# Access Compliance Report

## Public Rights-of-Way

Intersection ID: 10025077	Main Street: DOVE_MEADOW_DR	Cross Street: N/A	Location: NW
ADA ID: 860985AAD850	Ramp Type: Perp	Initial Pass/Fail: Fail	Overall Compliance: No
		Severity Score: 8.75

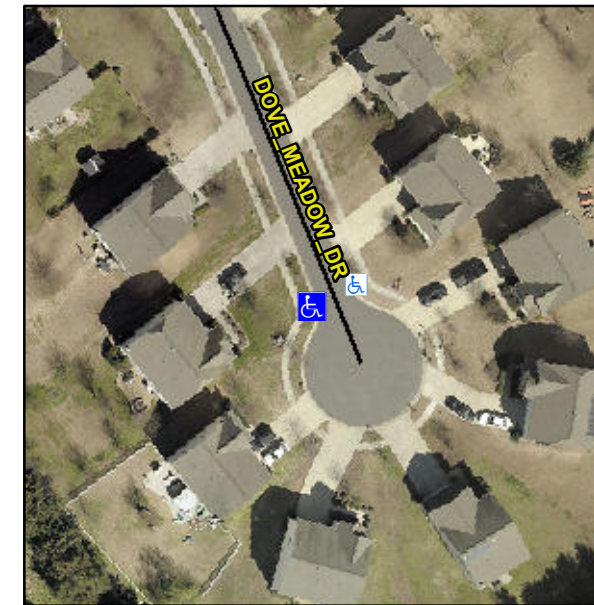
**R304.5.1**

Compliance	Description	Data	Compliance	Description	Data
N/A	Ramp Length (in)	75.0	Yes	Ramp Slope (%)	5.2
No	Ramp Width (in)	47.0	Yes	Ramp XSlope (%)	1.2
N/A	Flare Type LT	N/A	N/A	Flare Type RT	N/A
N/A	Flare Slope LT (%)	N/A	N/A	Flare Slope RT (%)	N/A
N/A	Flare Traversable LT?	N/A	N/A	Flare Traversable RT?	N/A
N/A	Landing Length (in)	N/A	N/A	DWS Provided?	N/A
N/A	Landing Width (in)	N/A	N/A	DWS Contrast?	N/A
N/A	Landing Slope (%)	N/A	N/A	DWS Length (in)	N/A
N/A	Landing X Slope (%)	N/A	N/A	DWS Full Width?	N/A
N/A	Landing Curb? (Y/N)	N/A	N/A	DWS Offset (in)	N/A
N/A	Shared Landing?	N/A			
N/A	Gutter Ponding?	N/A	N/A	Gutter Slope (%)	N/A
N/A	Gutter Lip Ht (in)	N/A	N/A	Gutter X Slope (%)	N/A
N/A	Painted X Walk1?	No	N/A	Painted X Walk2?	N/A
	X Walk 1 Direction	To NE		X Walk 2 Direction	N/A
N/A	X Walk 1 Width (in)	N/A	N/A	X Walk 2 Width (in)	N/A
	X Walk 1 Slope (%)	1.5		X Walk 2 Slope (%)	N/A
	X Walk 1 X Slope (%)	0.8		X Walk 2 X Slope (%)	N/A

**Remove & Replace Entire Ramp.**
